## Landscape Referral Response

<b>Application Number:</b>	DA2023/0951
<b>Date:</b>	01/02/2024
<b>Proposed Development:</b>	Alterations and additions to the Royal Motor Club Broken Bay
<b>Responsible Officer:</b>	Adam Croft
<b>Land to be developed (Address):</b>	Lot 5 DP 4689 , 46 Prince Alfred Parade NEWPORT NSW 2106 Lot 6 DP 110670 , 46 Prince Alfred Parade NEWPORT NSW 2106 Lot 262 DP 752046 , 46 Prince Alfred Parade NEWPORT NSW 2106 Lot 329 DP 824292 , 46 Prince Alfred Parade NEWPORT NSW 2106

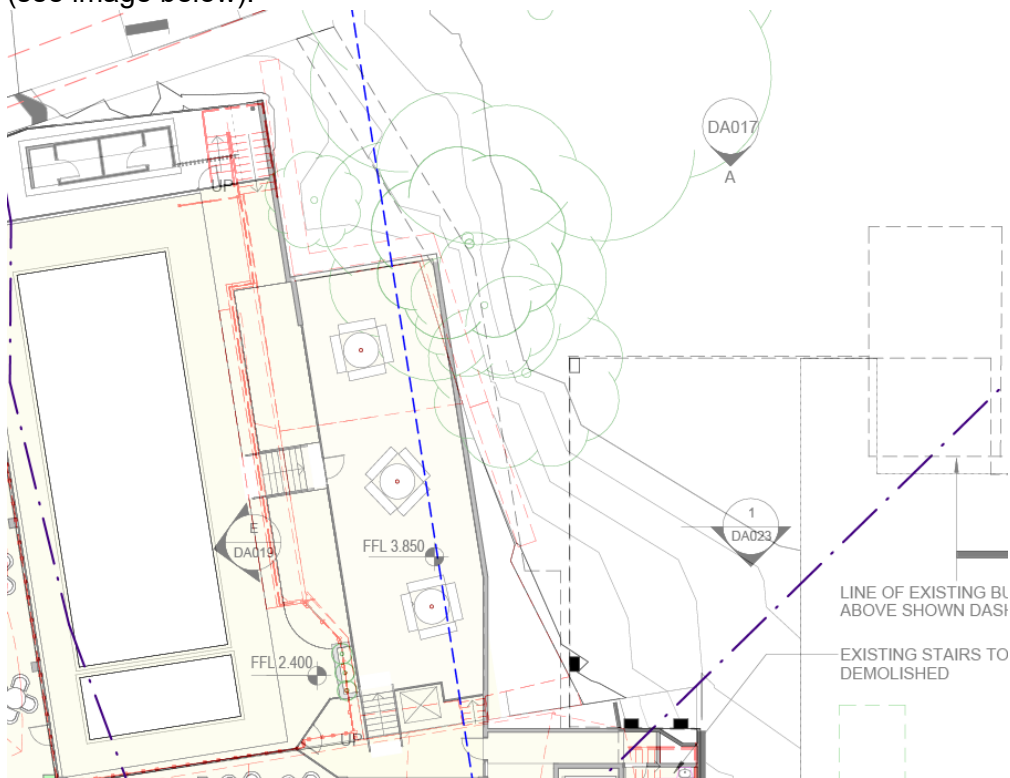
Landscape Referral does not support the removal of trees 2 and 4. An overlay of the drawings Demolition - First Floor Plan (DA004) and Proposed Partial Site - Ground Floor Plan (DA008) shows

that the proposed upper pool terrace area is mainly contained to the existing upper pool terrace area (see image below).

Any new retaining structures shall be wholly contained within the existing footprint of the upper pool terrace area, so as not to disturb existing trees 1, 2, and 4. The proposed service and fire egress pathway is labelled 'indicative location' on the plans. This pathway shall be located and designed in collaboration with the Arborist to ensure trees 1, 2, and 4 can be retained. The Arborist shall provide updated commentary on any design changes and to confirm the retention of trees 2 and 4.
